CITY PLAN COMMISSION STAFF REPORT

Antioch Manor Apartments

Plan Conditions, Corrections, & Recommendations Report

Case Number: CD-CPC-2021-00242

SITE PLAN

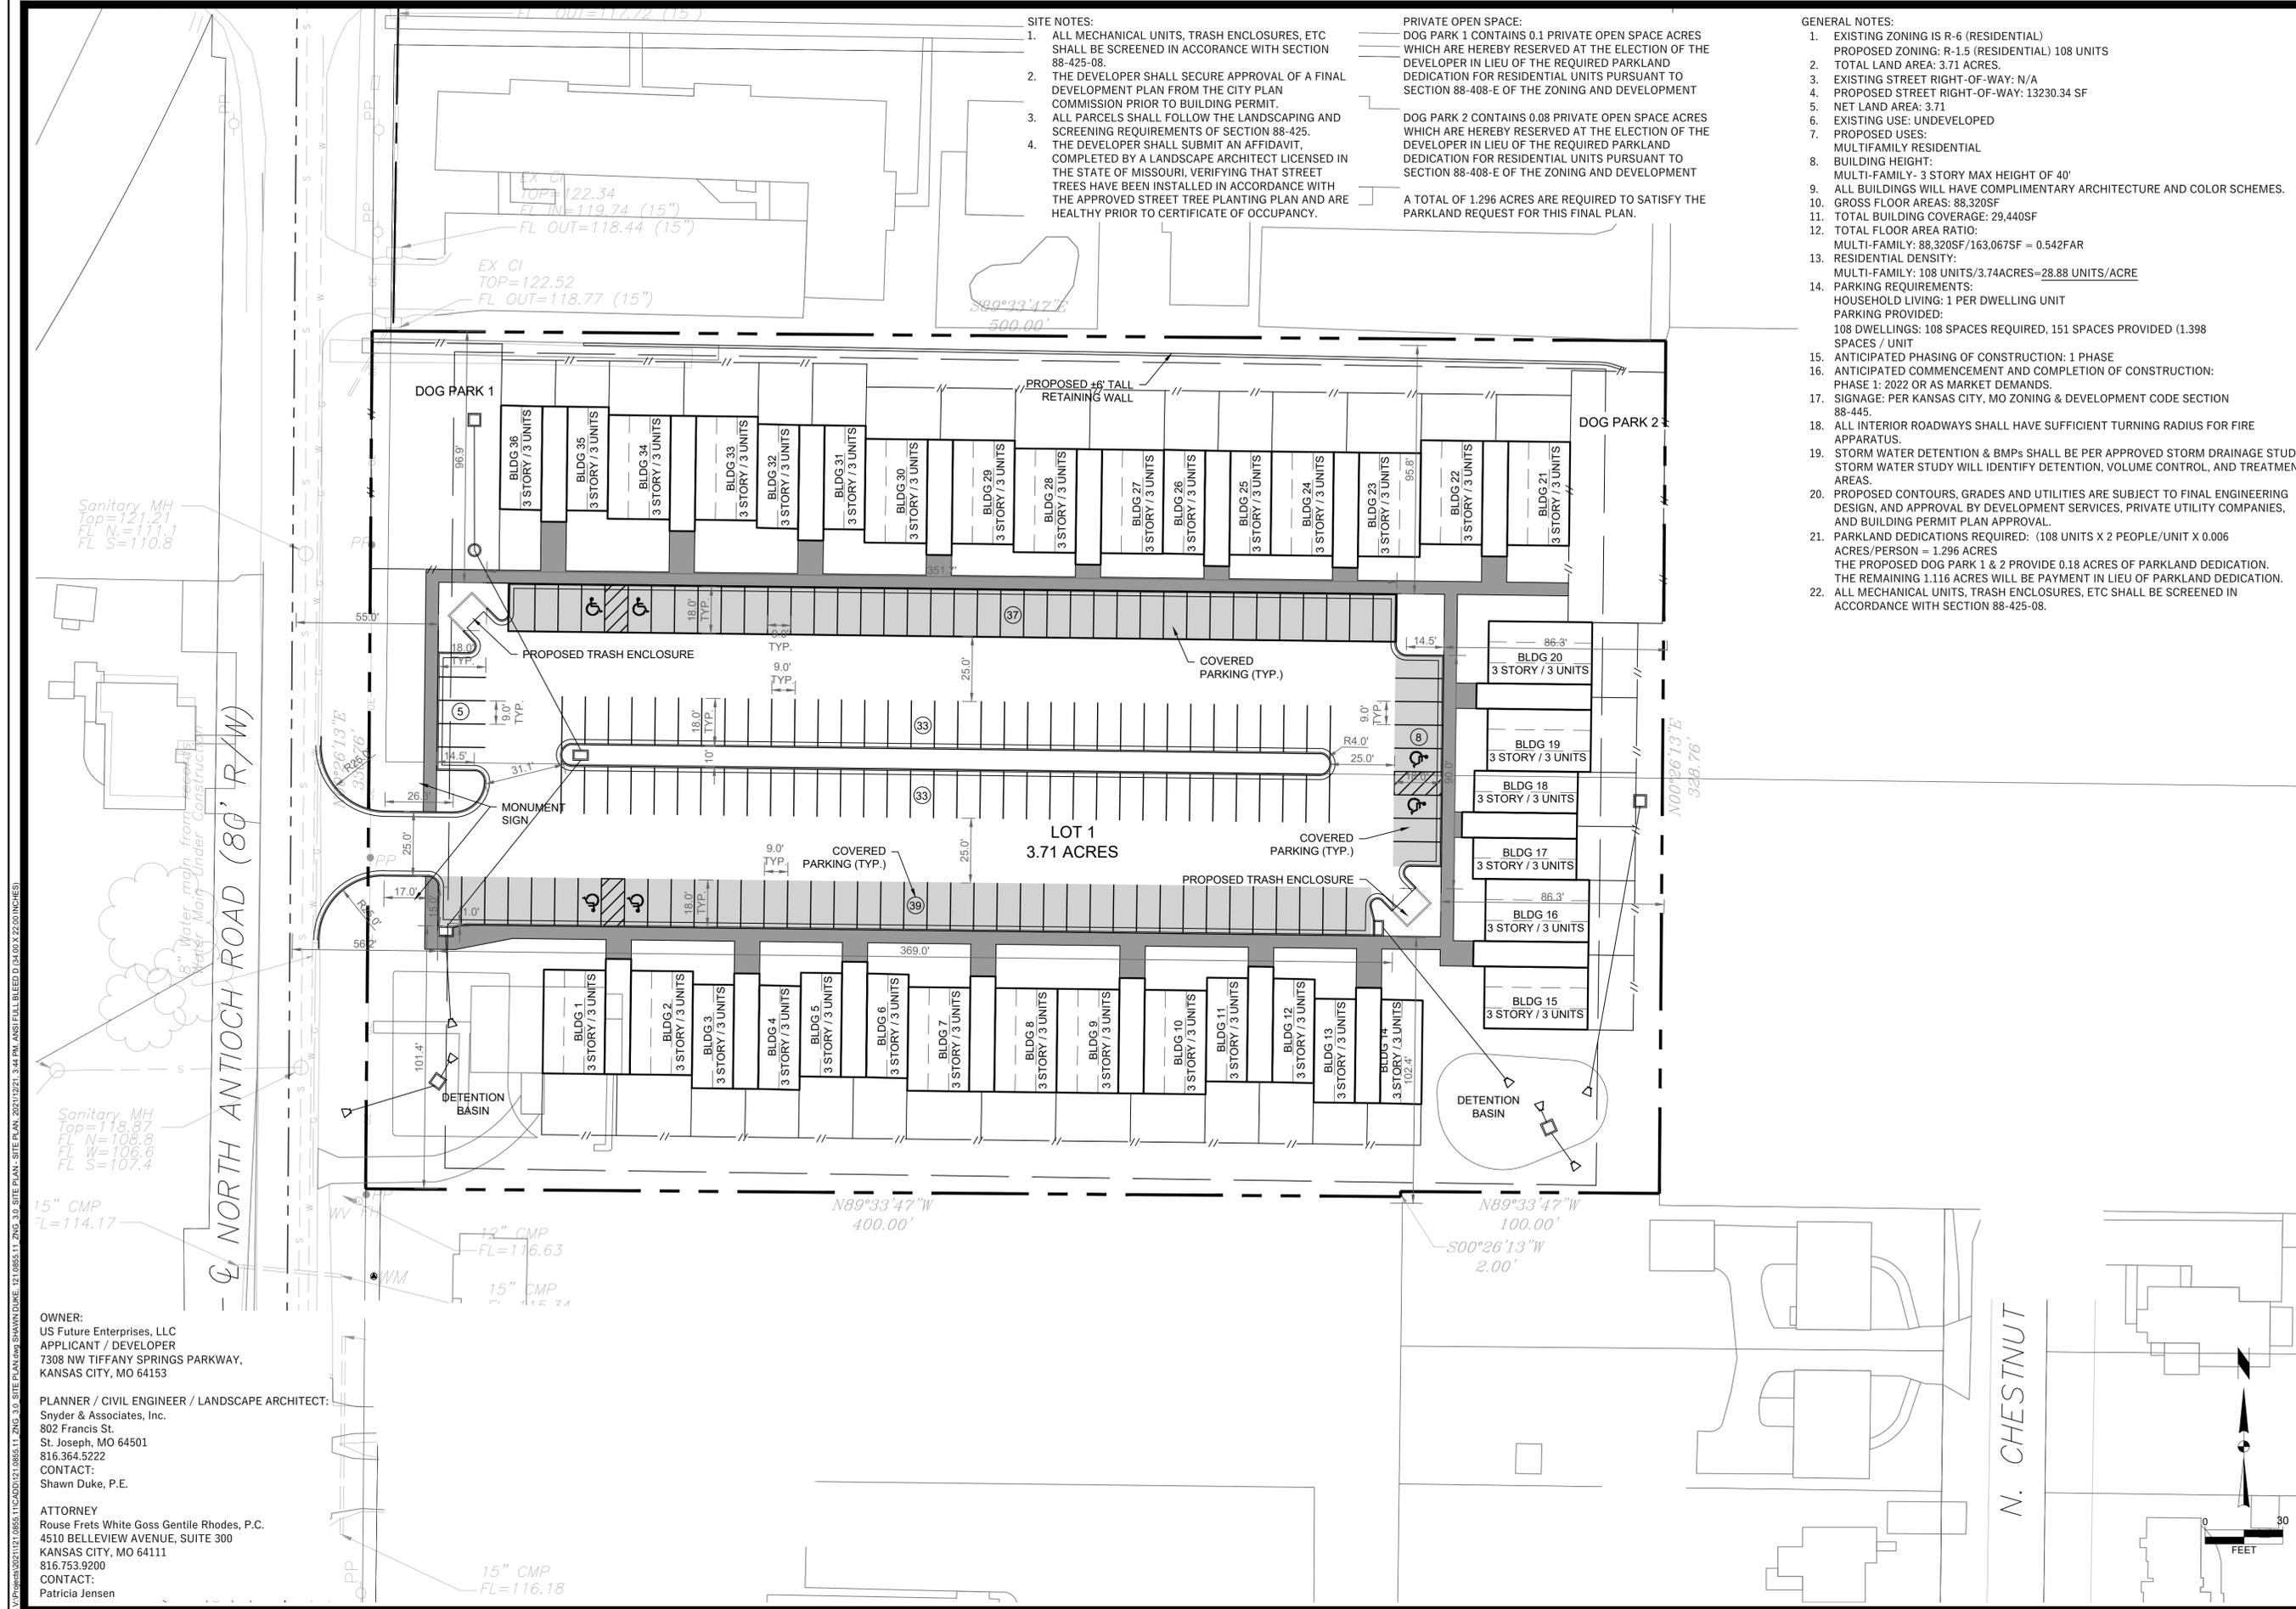
3. Layout – Revise plan to present buildings along N. Antioch Rd. rather than the proposed parking lot. Revise Plans and Resubmit (1/14/2022)
4. Consider breaking the buildings into smaller groupings. See sketch uploaded to CompassKC. Revise Plans and Resubmit (1/14/2022)

5. Provide private open space and usable amenities for the residents. Revise Plans and Resubmit (1/14/2022)
6. Show existing trees to be removed and trees to be preserved. Revise Plans and Resubmit (1/14/2022)

12. The proposed building setback lines on the face of the preliminary plat. Revise Plans and Resubmit (1/14/2022)
13. Proposed sidewalks and “cut-throughs” within the parking lots to provide pedestrian accessibility. Revise Plans and Resubmit (1/14/2022)

ANTIOCH MANOR REZONING & DEVELOPMENT PLAN
GRADING PLAN
SNYDER & ASSOCIATES
 ENGINEERS & PLANNERS, INC.

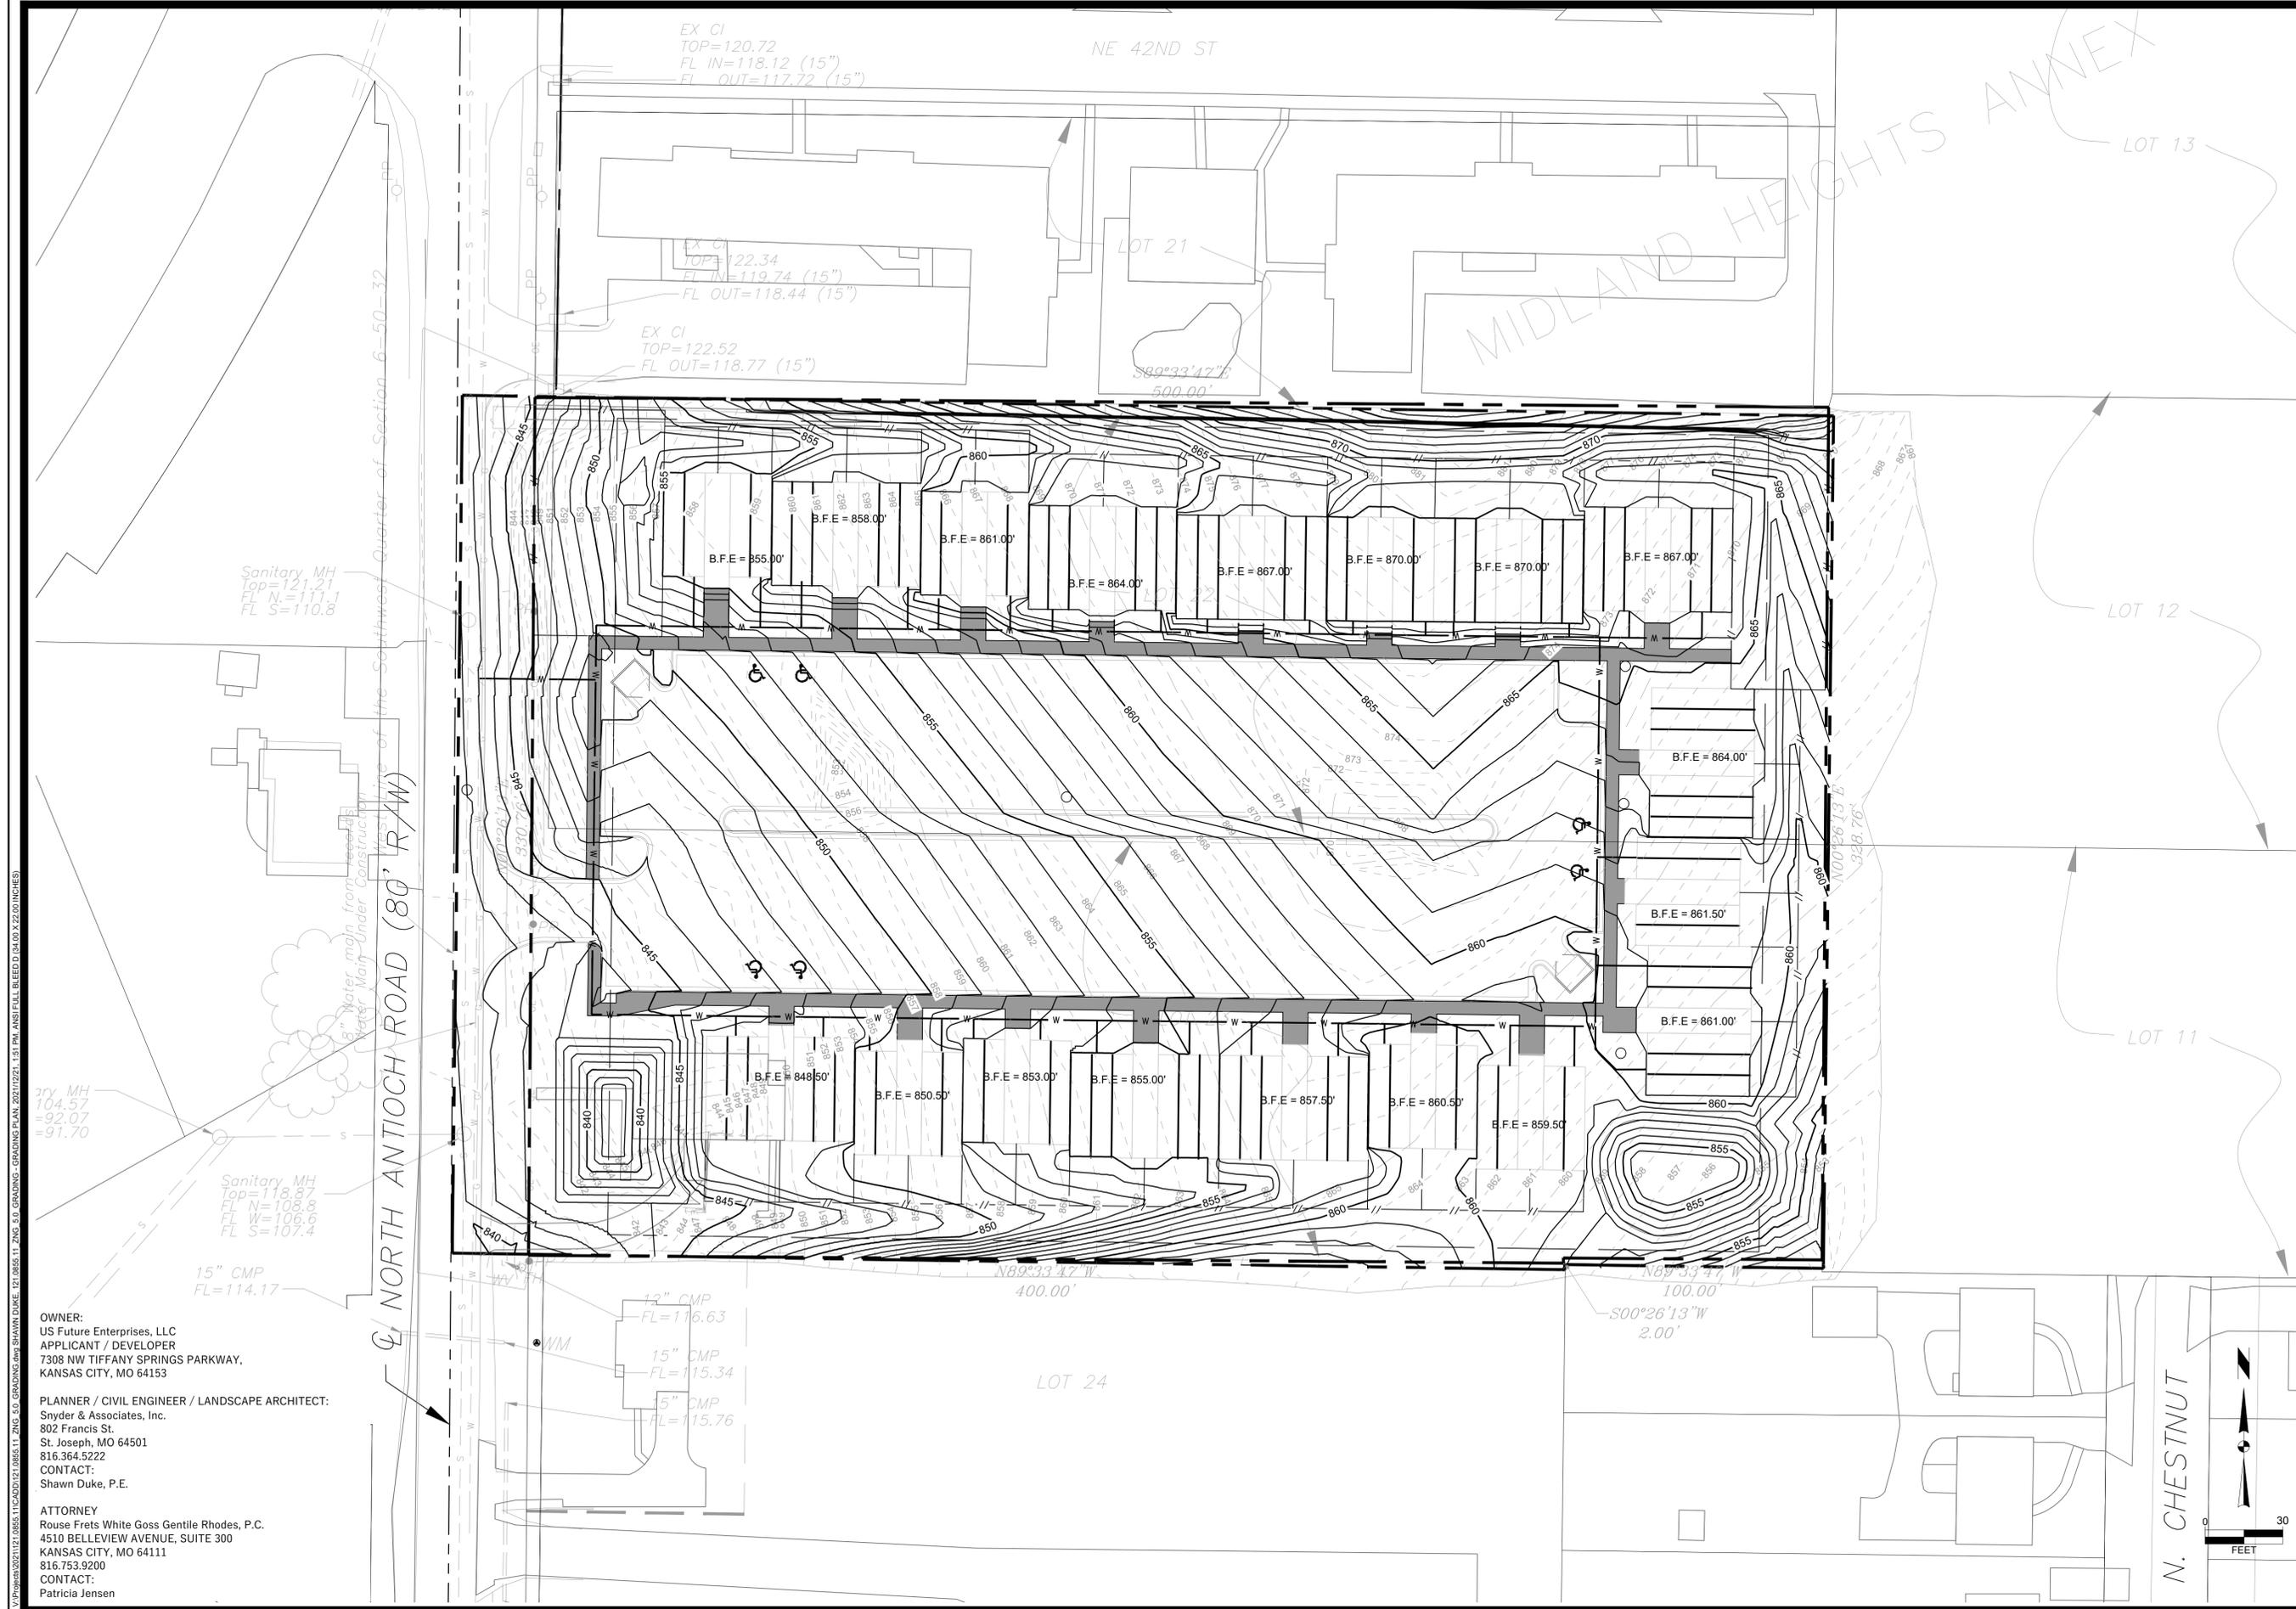
20. Ensure swale along east property boundary is routed to detention pond and does not bypass onto adjacent properties. (1/12/2022)

ANTIOCH MANOR REZONING & DEVELOPMENT PLAN
UTILITY PLAN
KANSAS CITY, MO
SNYDER & ASSOCIATES
 ENGINEERS & PLANNERS, INC.

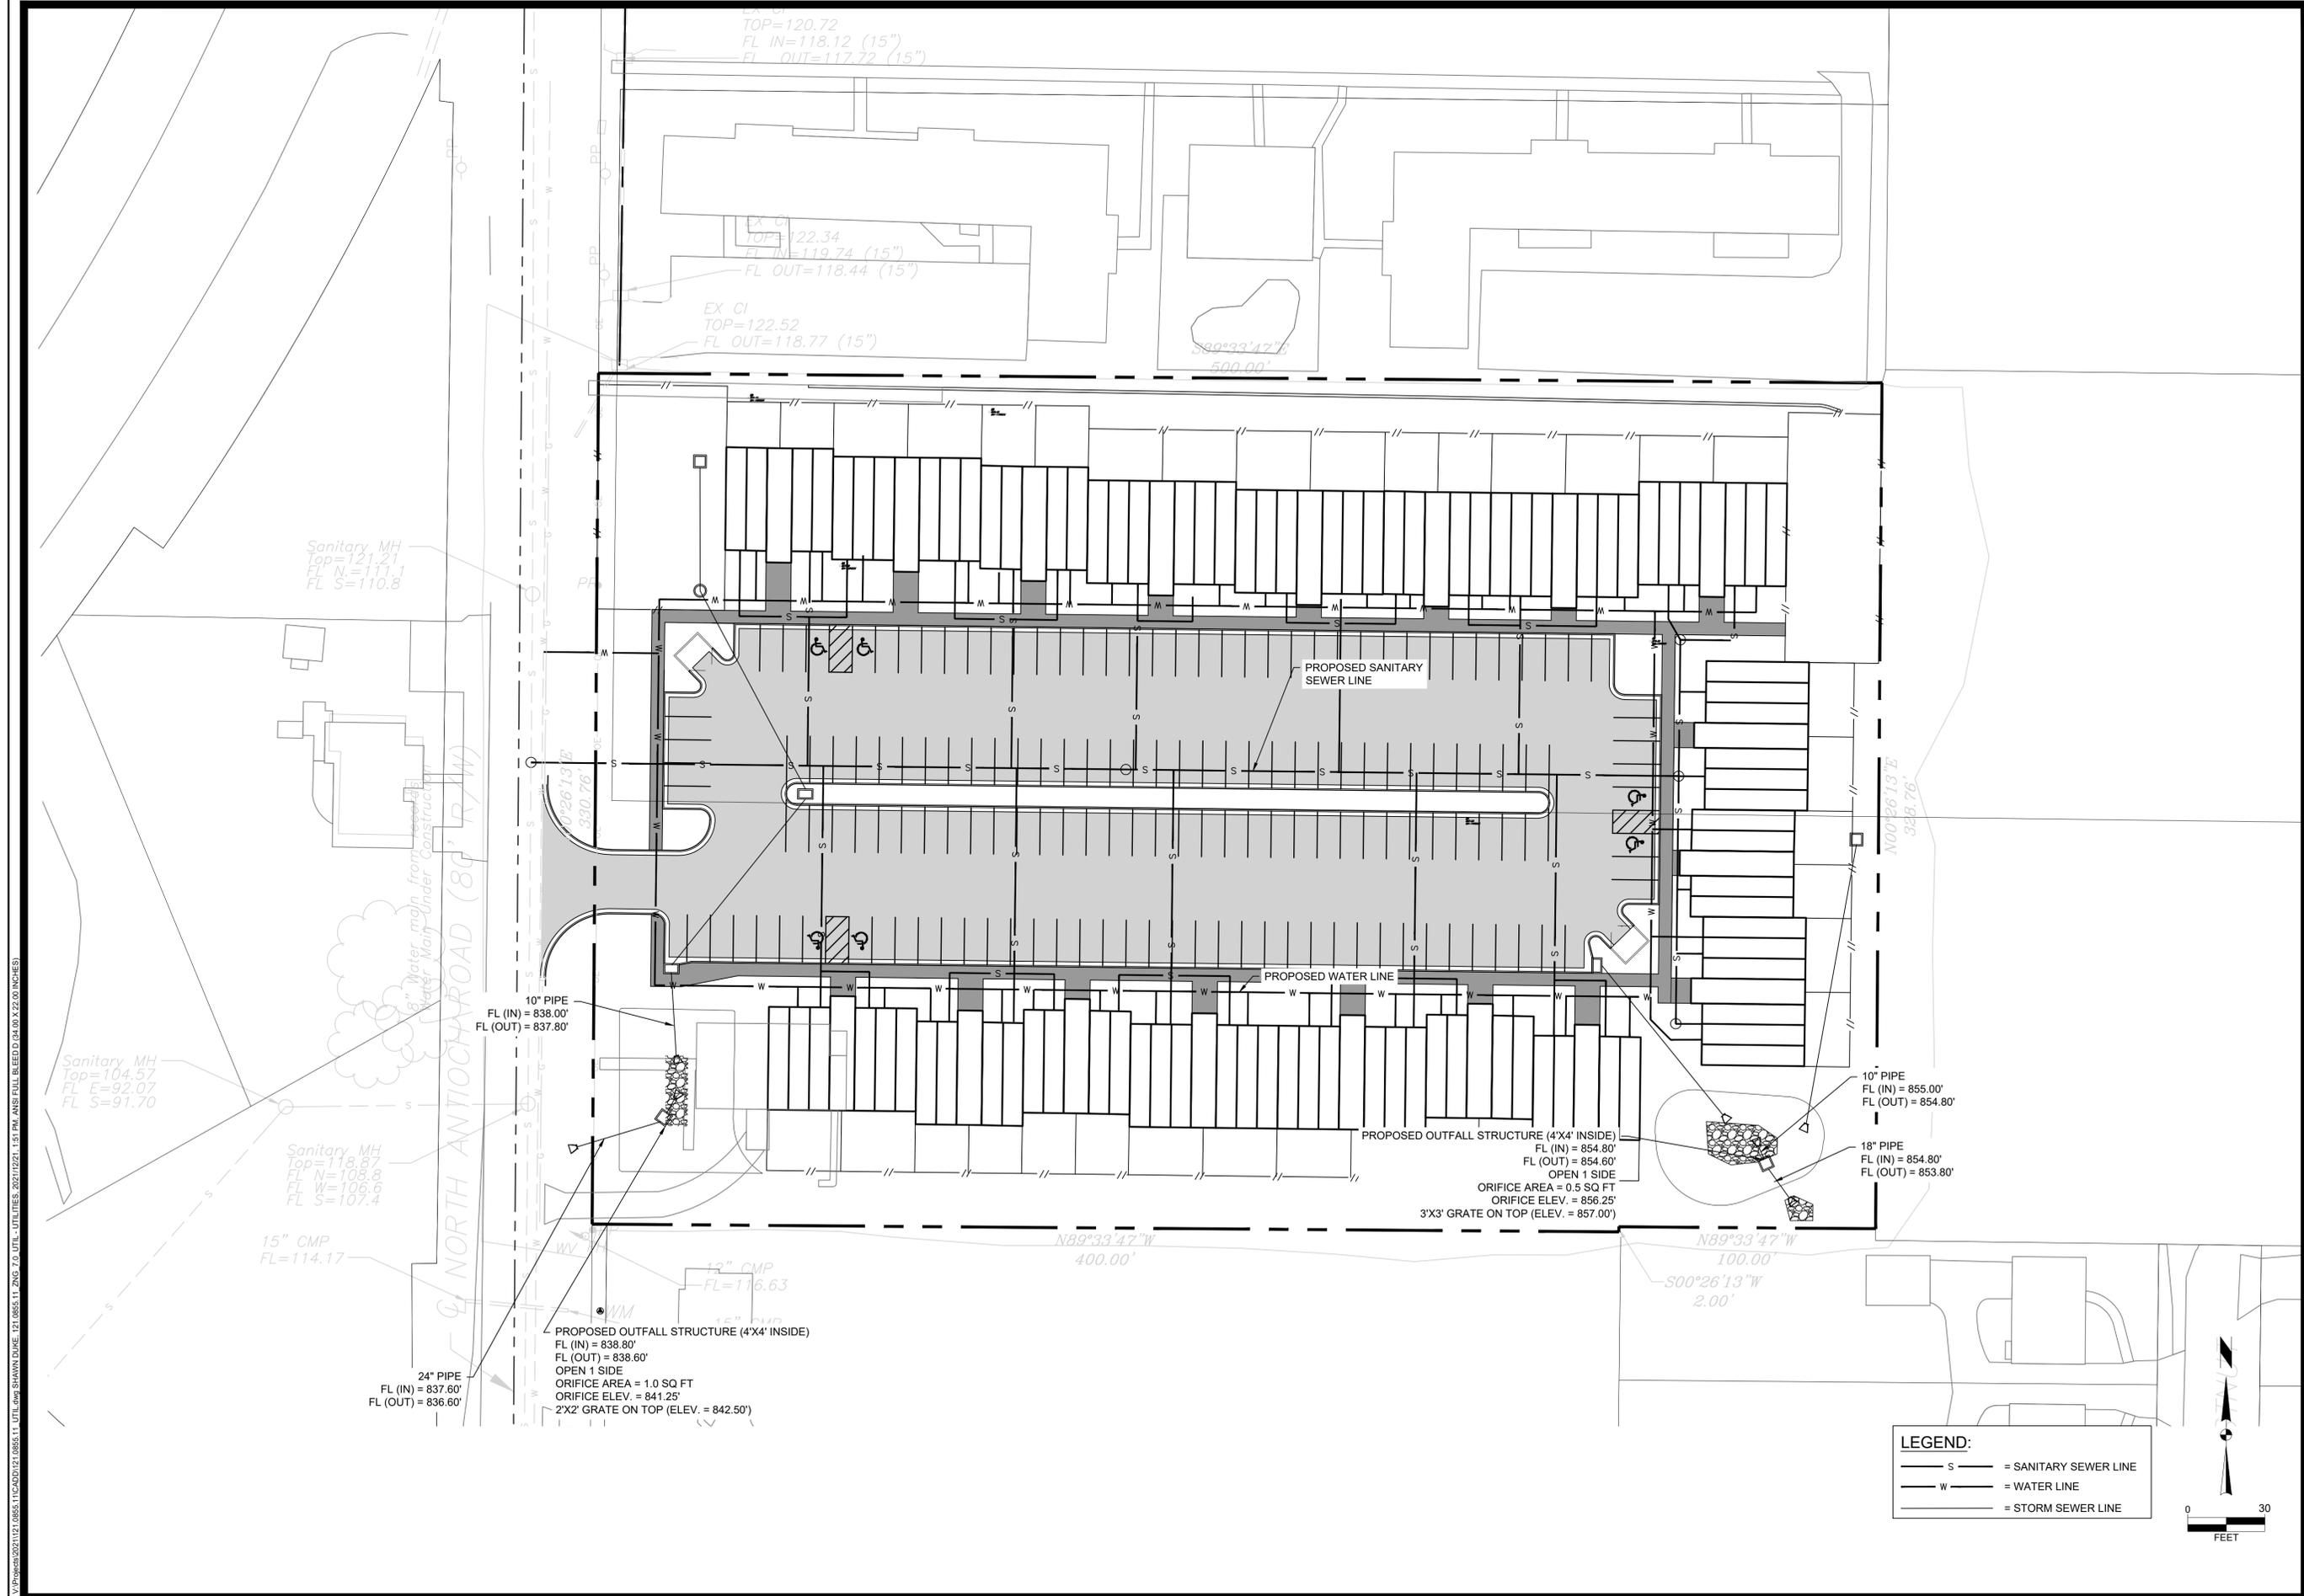
19. Only private water lines in private streets. Label what water lines are private water mains. (1/12/2022)
